REAL WORLD INTERFACES

Engineering Change Order ECO-DFTB-08-00: MIDI In and Out Systems prior to February 2016 which may cause pitch fluctuations in notes played by the Internal Sequencer

Robin Whittle 7 February 2016 www.firstpr.com.au/rwi/dfish/

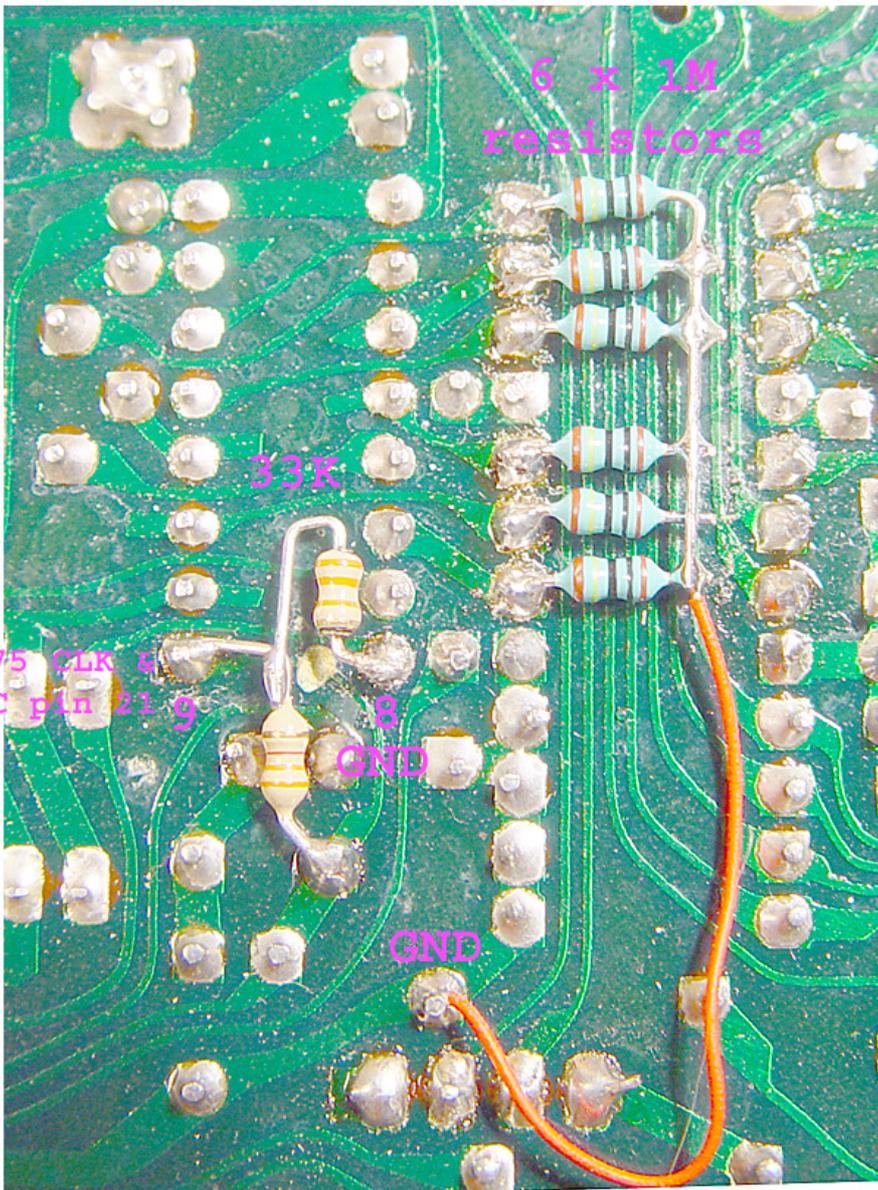
- 1 - A 0.125 watt (or at least a similarly small axial resistor, even if its wattage rating is higher) 33k resistor between ground and the Clock pin 9 of the 4174. In this way, the Clock pin and the blue wire (soldered to pin 9 on the top side of the board, which you can't see if only the rear part of the case is removed) driving pin 21 of the PIC is the result of a 3.3k to 33k voltage divider. This means that the 4174 and the PIC get 10/11 of the voltage produced by the TB-303 CPU pin, and that pin's most positive voltage is now reduced somewhat by this new path to ground. Solder the resistor between pin 8 (ground) and the 3.3k resistor's wire to pin 9. It is best to solder the pin 9 connection to the lead of the 3.3k resistor, rather than to pin 9 itself, in case the heat from the soldering iron desolders the blue wire on the top side which is soldered to that pin. Fixing this would involve some disassembly and reassembly.

- 2 - Solder six 1M 0.125 watt resistors so that the right end goes to the right end of one of the 6 new 100 k resistors I installed in place of wire links, and so the left ends all go to ground.

The following photo shows how this can be done.
